Re: Site Plan Modification – Response to Comments
Cherry Valley 1.0 MW PV Array
148 Henshaw Street
Town Assessor's Map 24, Lot A2 0
Leicester, Massachusetts

On behalf of ZPT Energy Solutions, LLC, Fuss & O'Neill has prepared this letter in response to the 148 Henshaw Street Cherry Valley 1.0 MW PV Array letter, sent by Quinn Engineering, Inc., dated August 16, 2016. Our response to Quinn Engineering's additional comment is detailed below.

Earthwork Volume Report

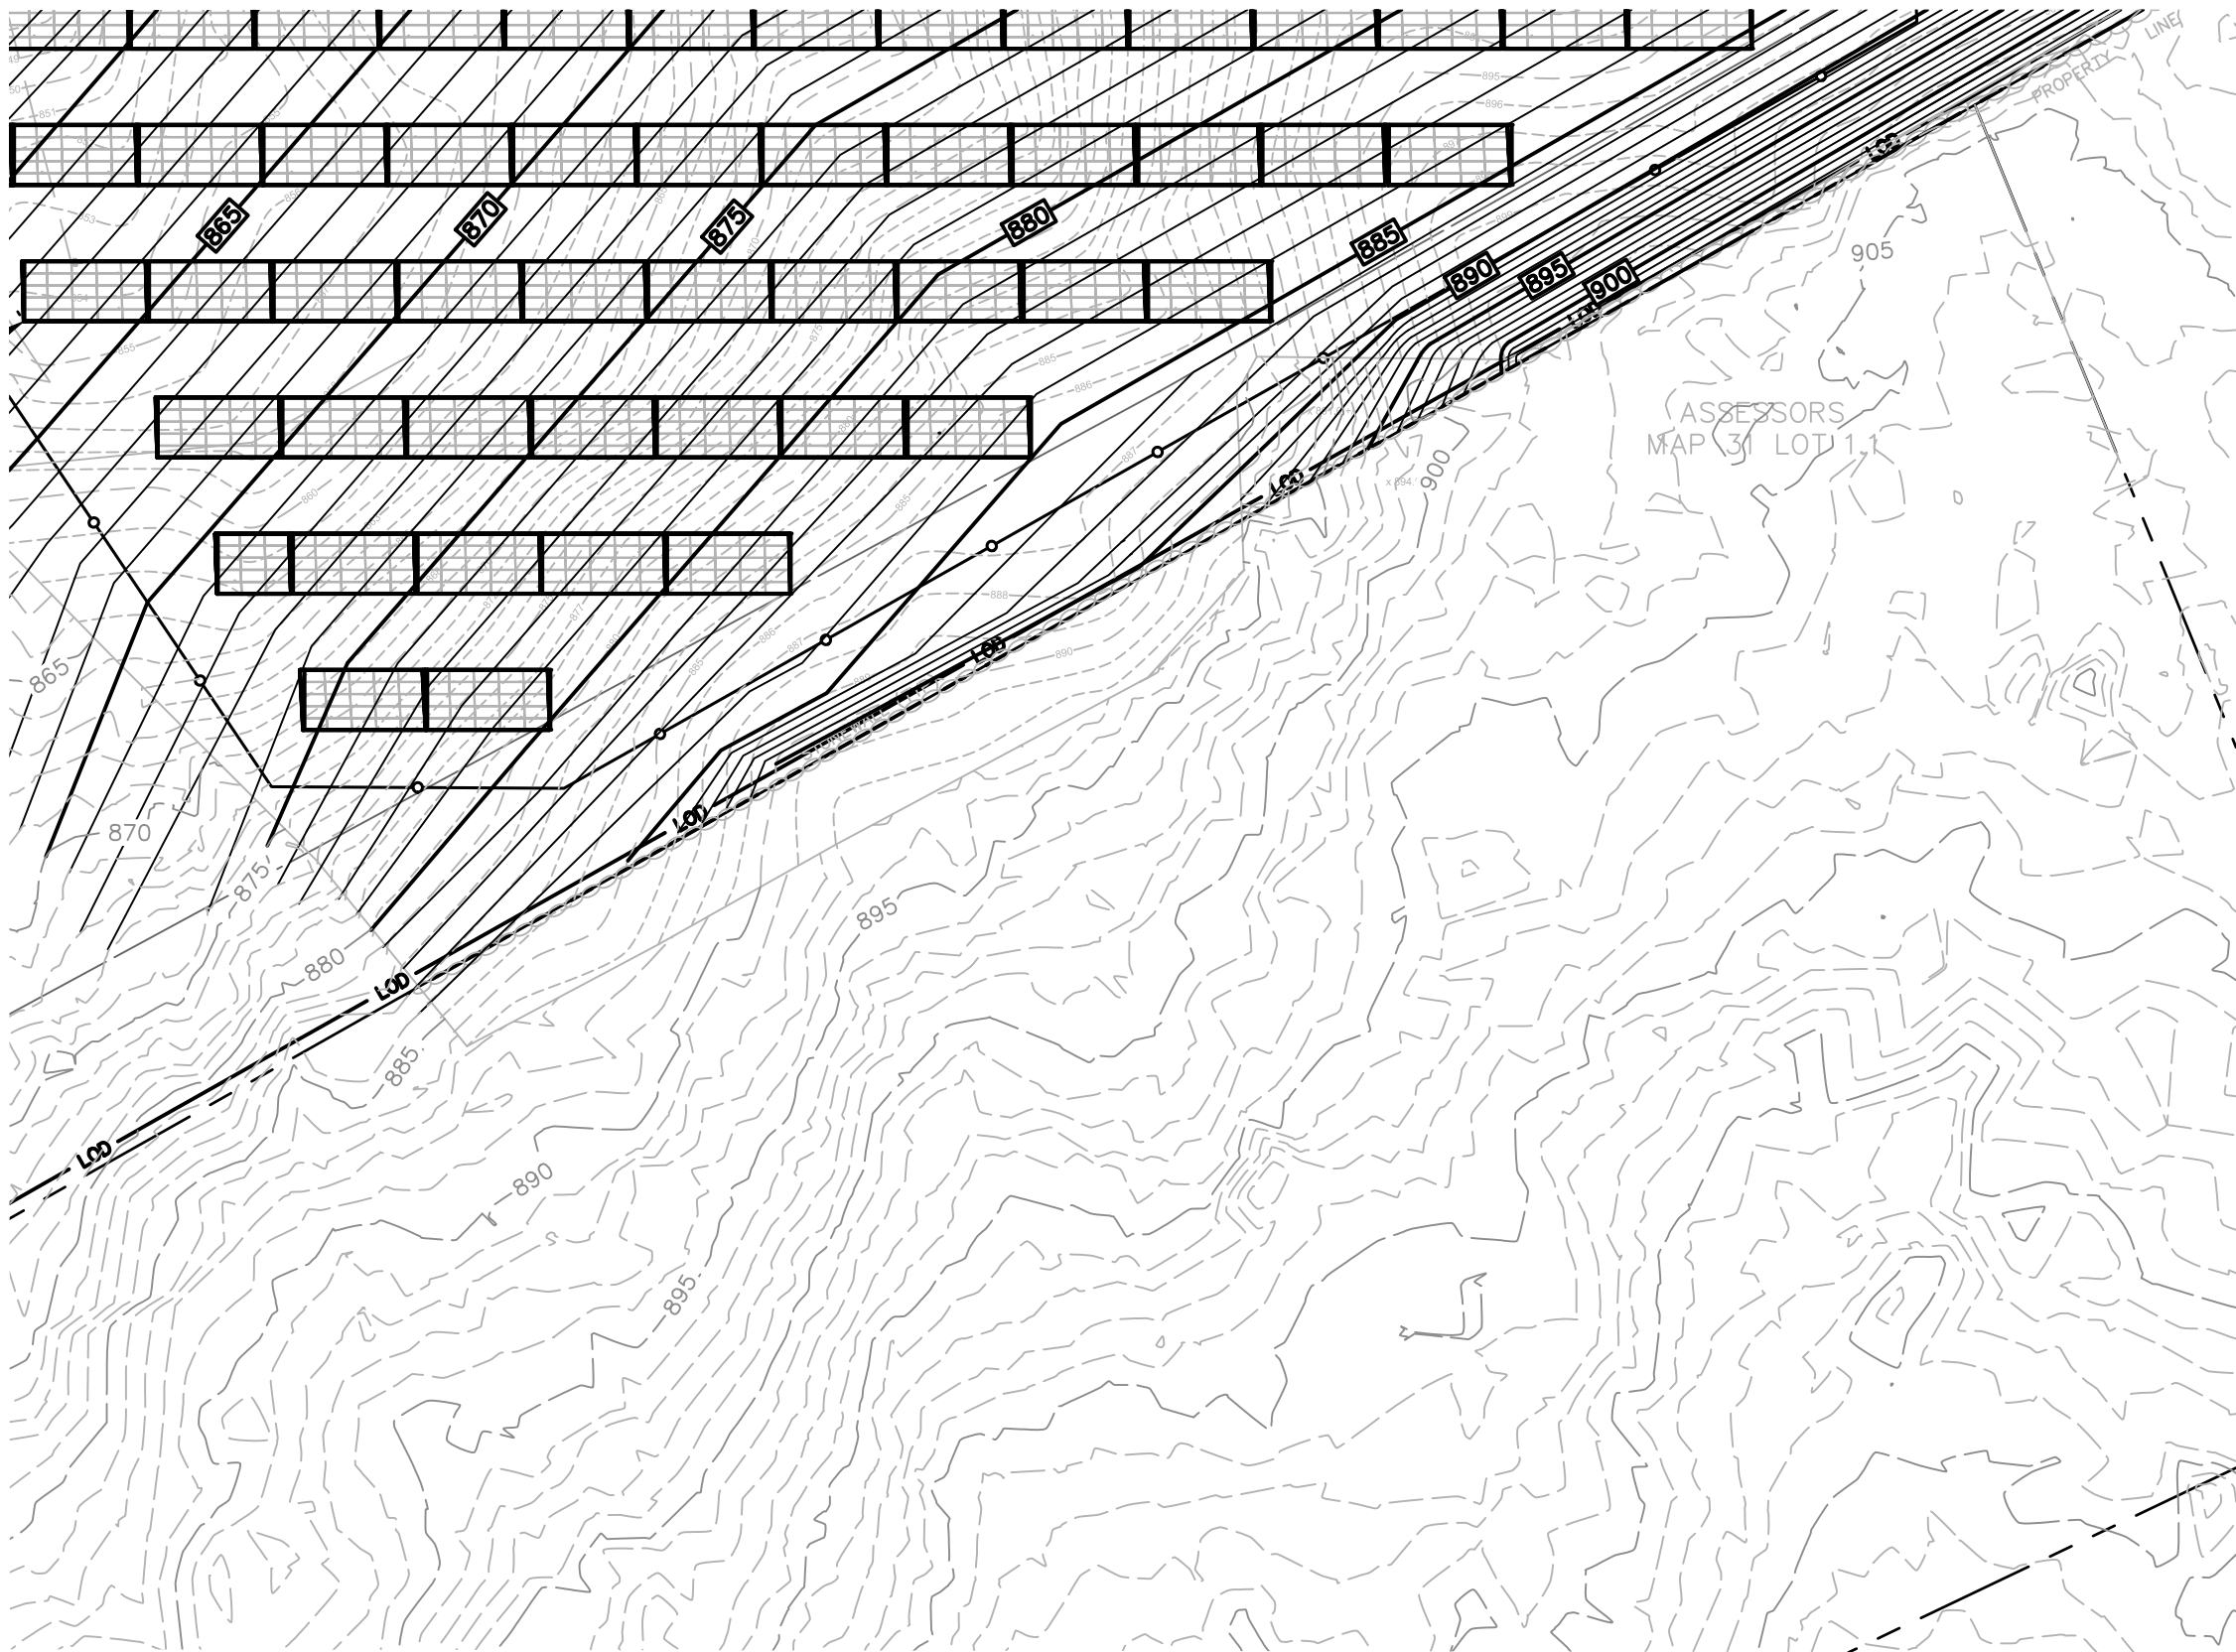
4. *The proposed volume of earthwork should be updated. (Ref. II.A.9).*

Response: Revised earthwork calculations are attached. The result of the attached earthwork volume report indicate a net fill. However, the intent of the grading is to avoid importing or exporting material from the site, and the slope within the array field may be slightly adjusted depending on the volume of soil material available.

CS-103

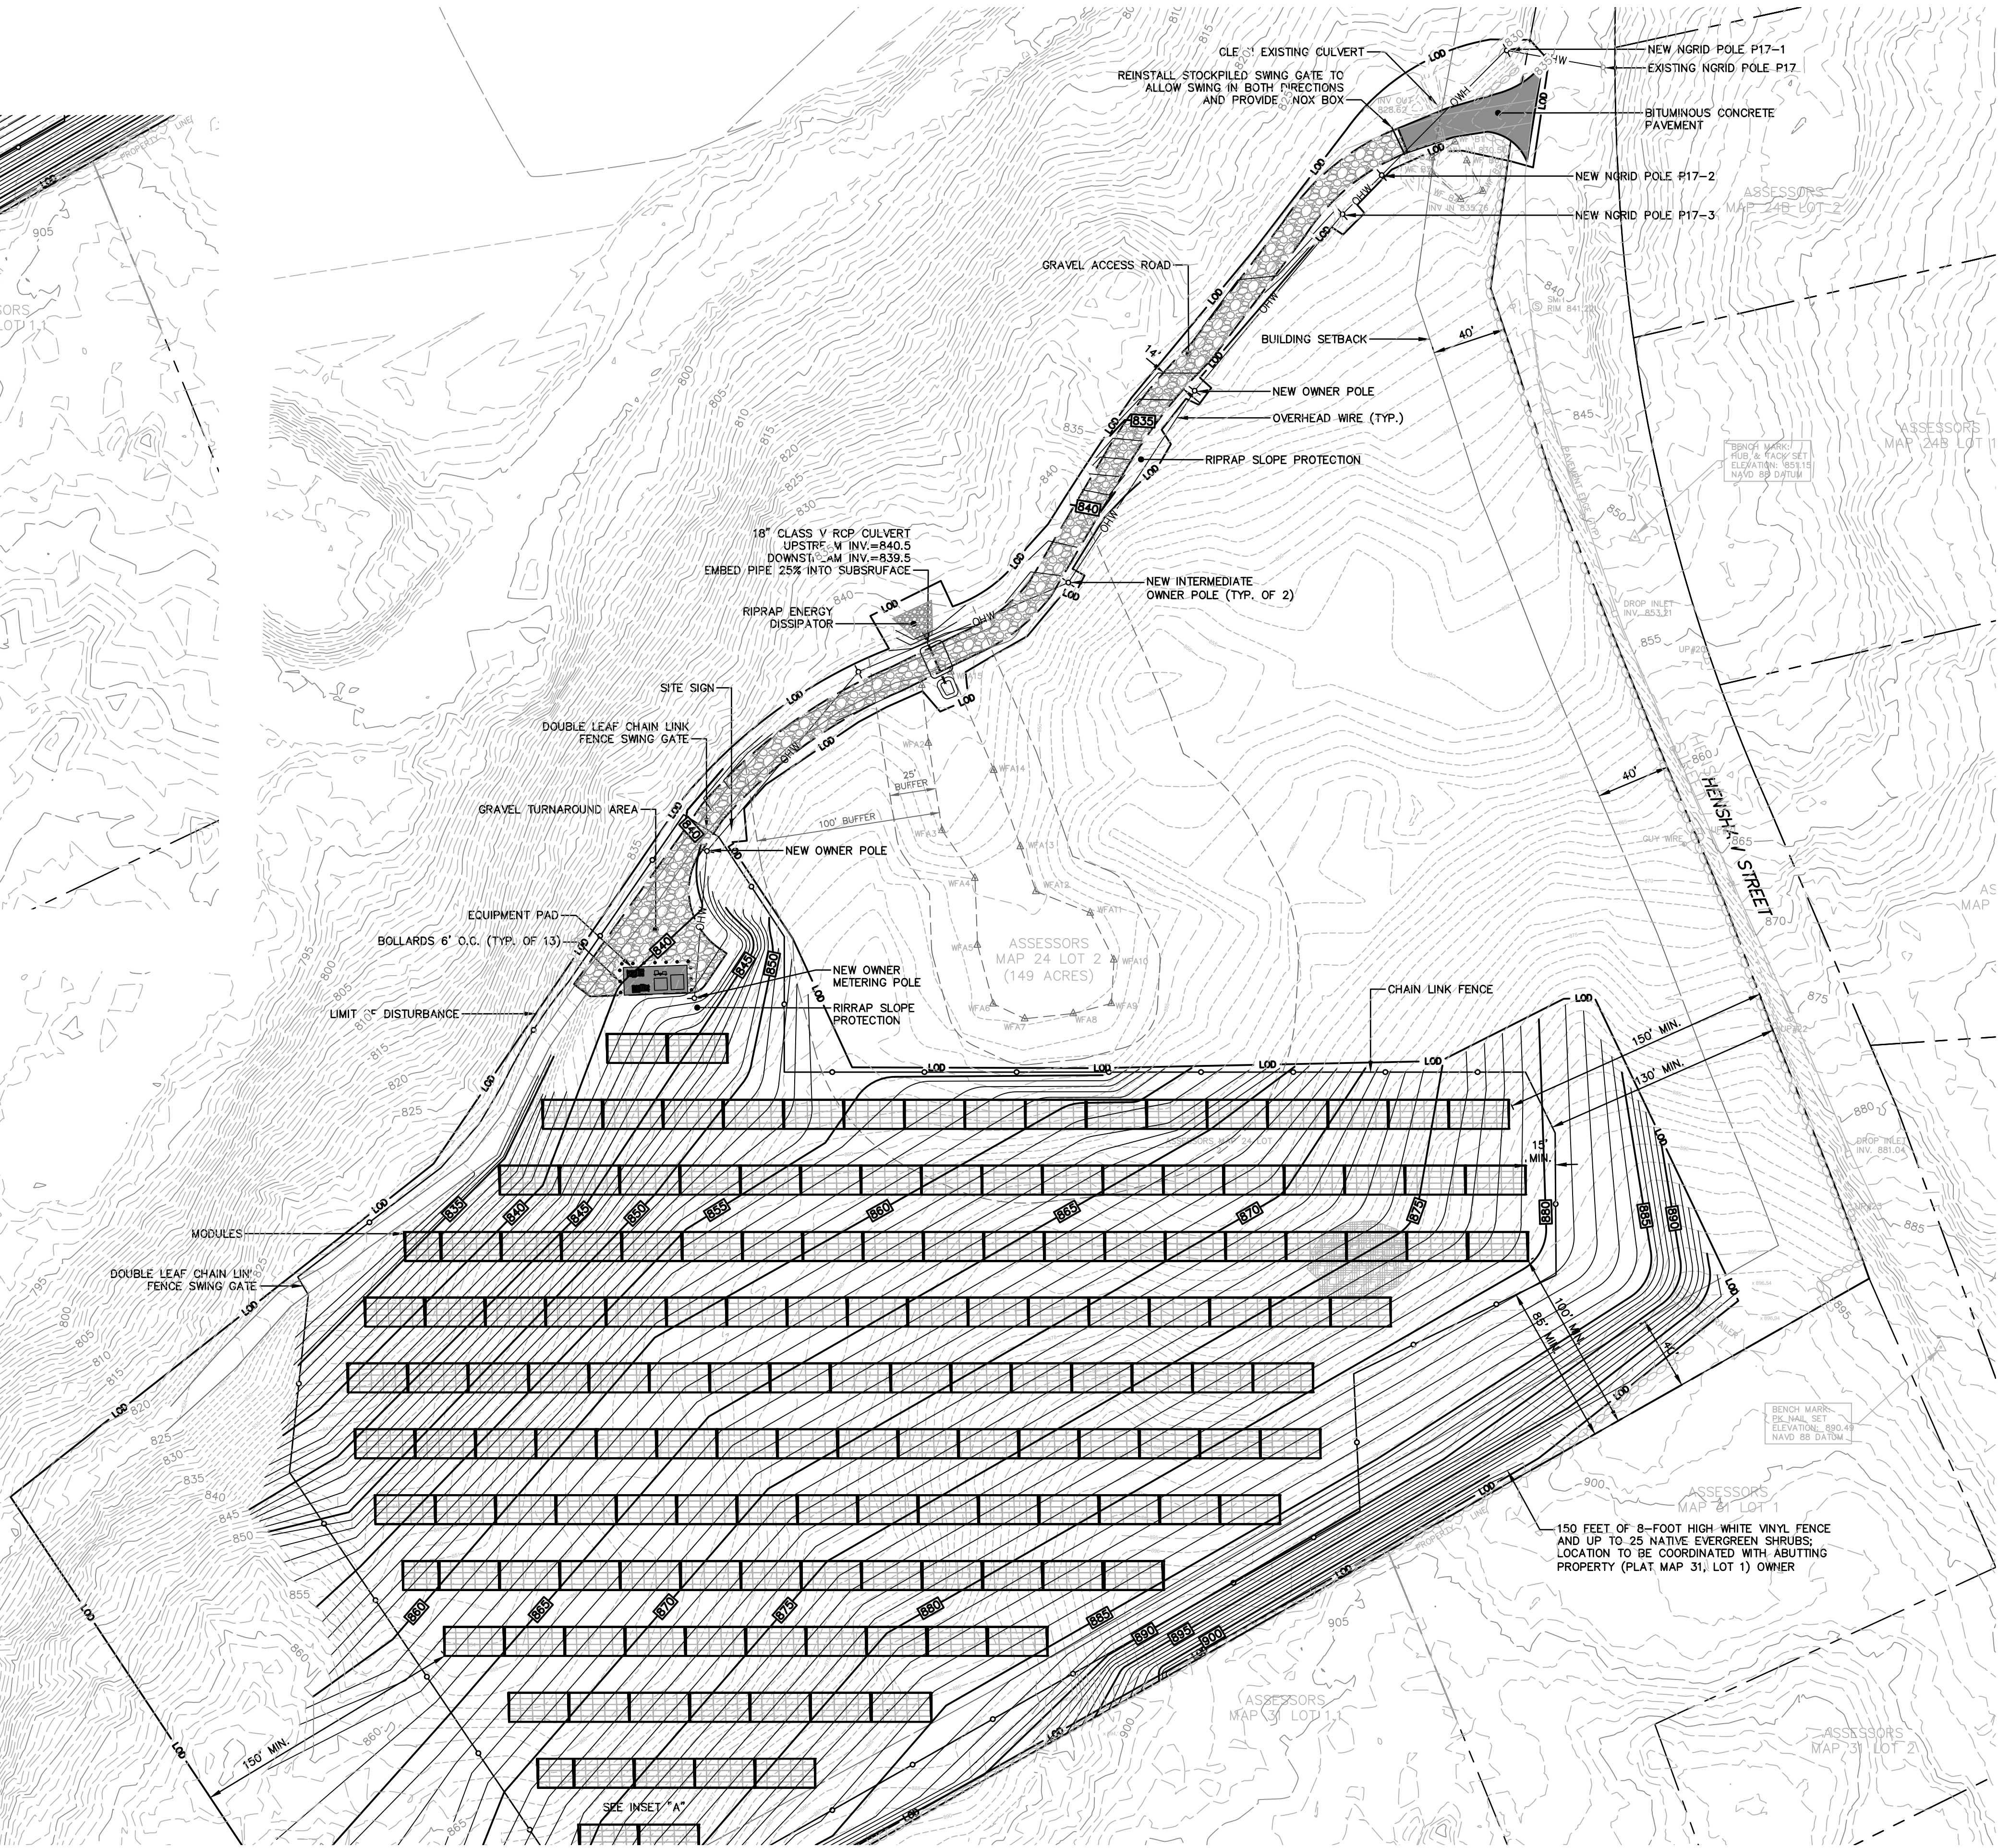
1. *The panels have not been depicted on the plans. (Ref. II.A.7 and LSR 4.0.A.6).*

2. *Existing topography is missing from the southern and western sides of the proposed work. Information depicting the extent of grading and how the proposed contours tie into the existing contours should be provided. (Ref. II.A.8 and LSR 4.0.A.7).*

3. *Proposed contours along the southern property boundary should tie into existing contours that extend off site, otherwise, it is not clear how the proposed grades match into the existing. As currently drafted, it appears that there is potential to create low points along the southern boundary that will trap runoff. (Ref. II.A.8 and LSR 4.0.A.7).*

5. *Some of the proposed cuts are in the range of 13 feet deep. A ledge outcrop is shown on the plan within the eastern portion of the grading. If blasting is required, it should be conducted in accordance with all local, state and federal requirements.*

6. *There is potential for the proposed earthwork cuts to intercept the seasonal high groundwater table. Information related to the groundwater table elevation should be provided. If abundant groundwater is present, diversion swales may be necessary and additional stabilization of the slopes beyond the proposed loam and grass seed mixture may be required.*

7. *Removal of the trailer in the southeastern portion of the grading is required. Removal should be coordinated with the trailer's owner.*

Response: The panels are depicted on Sheet CS-103.

Response: Contours for the southern and western sides of the proposed work were generated utilizing GIS LiDAR point cloud data, as they are outside of the survey extents. The LiDAR generated contours were found to closely match the surveyed topography and provide accuracy sufficient to clearly depict how proposed contours will tie in.

Response: Proposed contours along the southern end of the property tie into the existing stone wall along the property line. As depicted on the revised Site Plan, the southern abutting property is at a higher elevation than the site and will facilitate drainage northerly across the site.

Response: Depending on the extent of ledge encountered during site grading, either a pneumatic hammer or blasting will be utilized. Any blasting performed will be conducted in accordance with all local, state, and federal requirements.

Response: We would like to defer conducting test pits until construction has begun and construction equipment is mobilized. Diversion swales shall be installed if seasonal high groundwater is encountered during earthwork operations.

Response: Relocation of the abutting property owner's trailer has been coordinated with property owner.
